WATTS BAR NUCLEAR PLANT (WBN) UNITS 1 AND 2 - RESPONSE TO NRC INFORMATION REQUEST (TAC R00514, M73097, M73098)

Reference: NRC Audit Summary - Report on the September 1991 Civil Calculation Audit (TAC R00514, M73097, M73098) Dated January 31, 1992

WATTS BAR NUCLEAR PLANT  
NRC SEPTEMBER 1991 CIVIL CALCULATION AUDIT  
RESPONSE TO REQUEST FOR ADDITIONAL INFORMATION

SKETCH 1

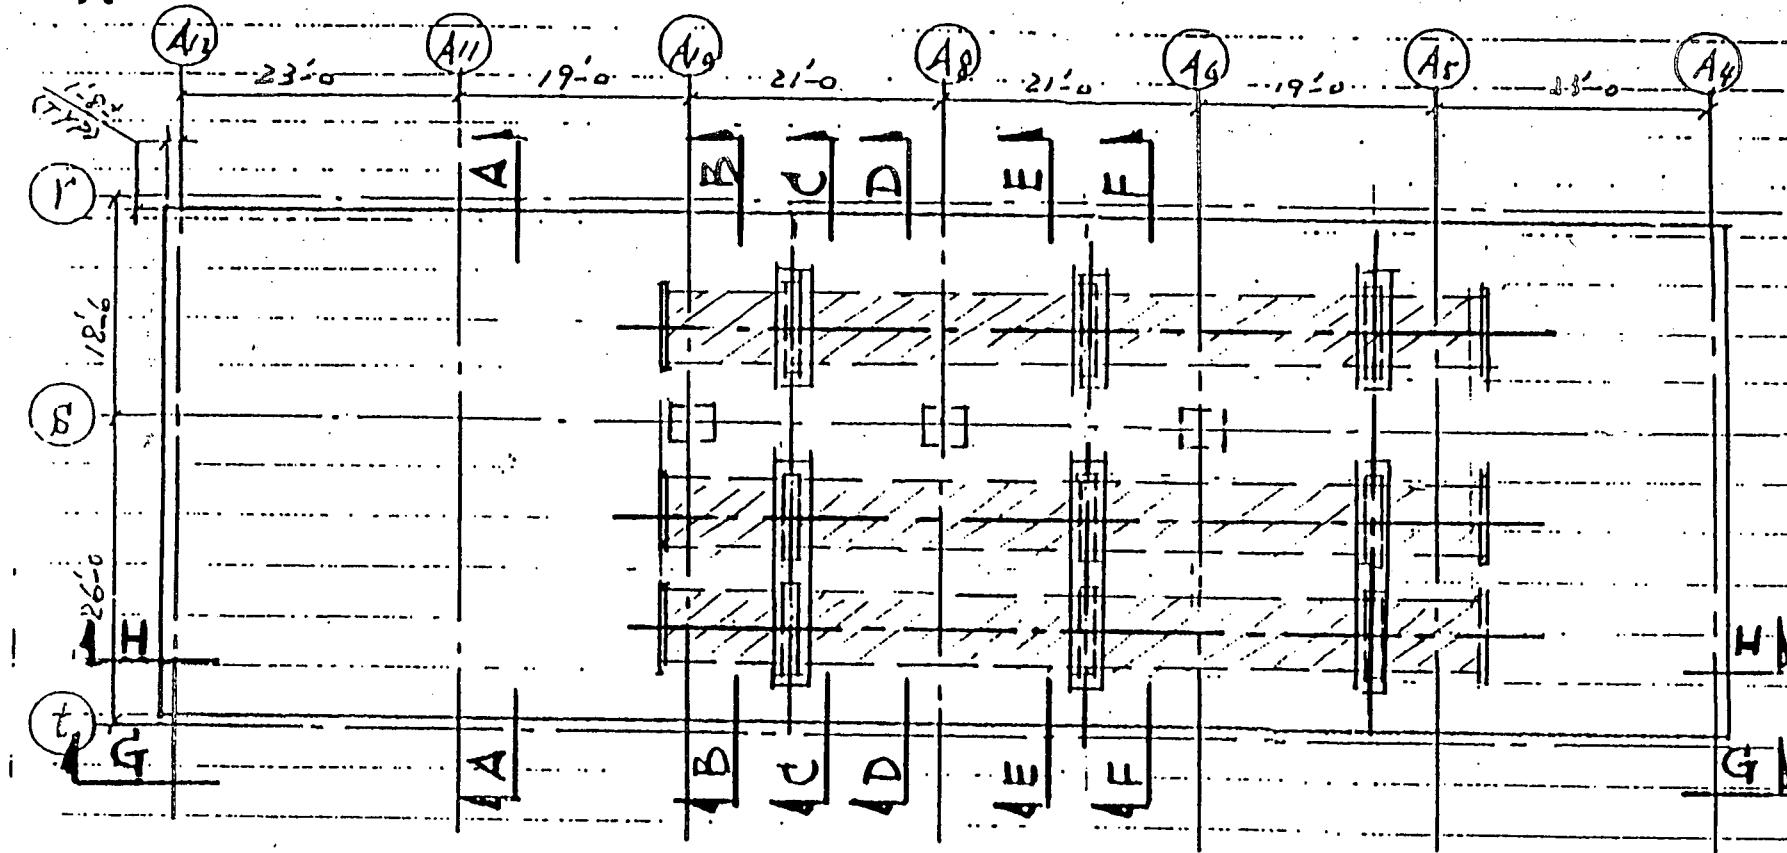
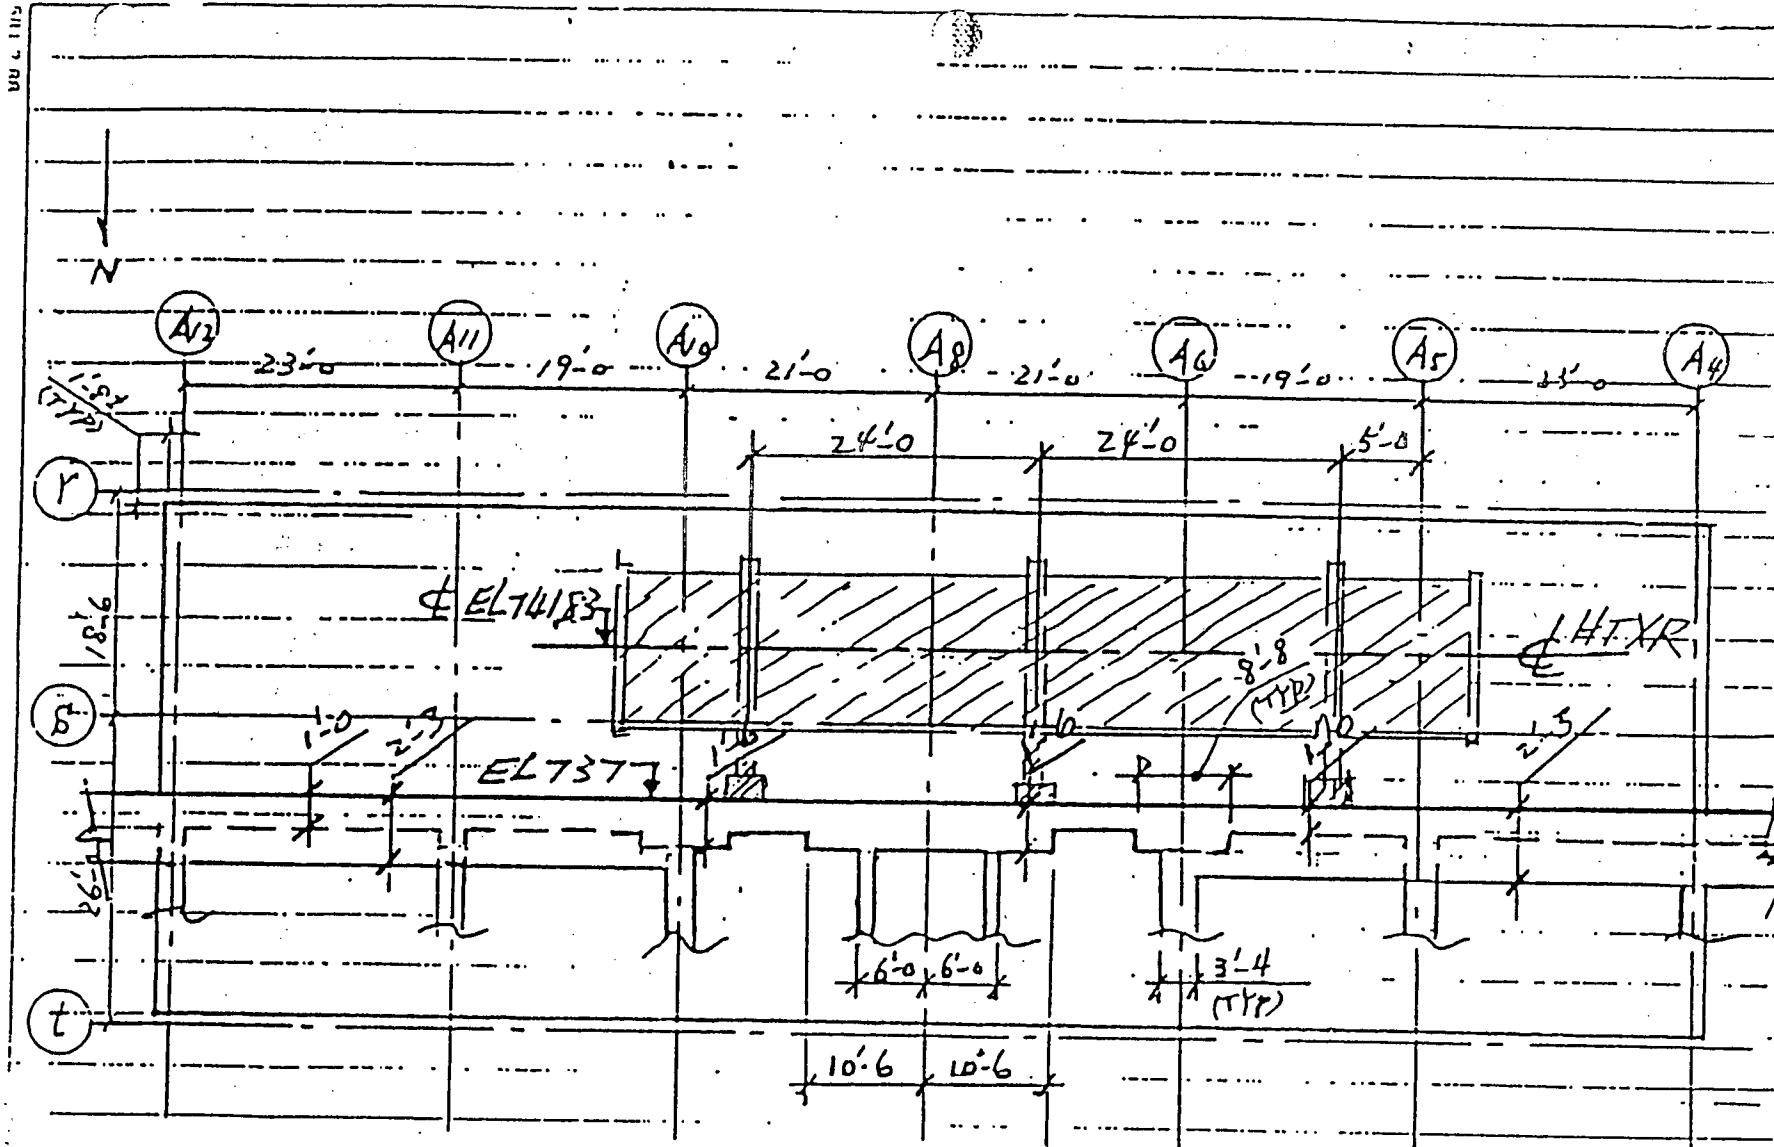
TVA should show the validity of reaction forces and adequacy of the finite element model at the boundary of the slab for calculation WCG-1-923. This evaluation should also be extended to finite element models used for the evaluation of other slab areas.

The arrangement of the equipment and the positioning of the columns supporting the one-foot thick slab at elevation 737 between column lines "r" and "t," as shown on Sketch 1 of Attachment 1, is one of the worst case slab loadings due to the component cooling water heat exchangers. The slab model spans between column lines "r" and "t." The conditions along column line "r" have a continuous beam and were therefore vertically restrained in the model. The conditions along column line "t" have a series of slabs of different thicknesses, intersecting walls and drop panels for columns (see Sketch 2). All slabs thicker than one foot were restrained in the vertical direction while one-foot thick slabs were freed. This model of the boundary conditions resulted in the reaction patterns at column line "t," which include irregular downward and some upward reactions in the vicinities of the freed slab edges. These effects of the idealized model along column line "t" are localized largely in the vicinity of the boundary itself, and rapidly attenuate with distance away from the column line. Sketch 3 provides a deflected shape along the column line "t" at an offset of 4 feet. In contrast the structural behavior of the slab away from column line "t" and in the areas of expected high stress is realistic and accurate. Therefore, the model used in calculation WCG-1-923 is adequate for the evaluation of the slab around column line "s."
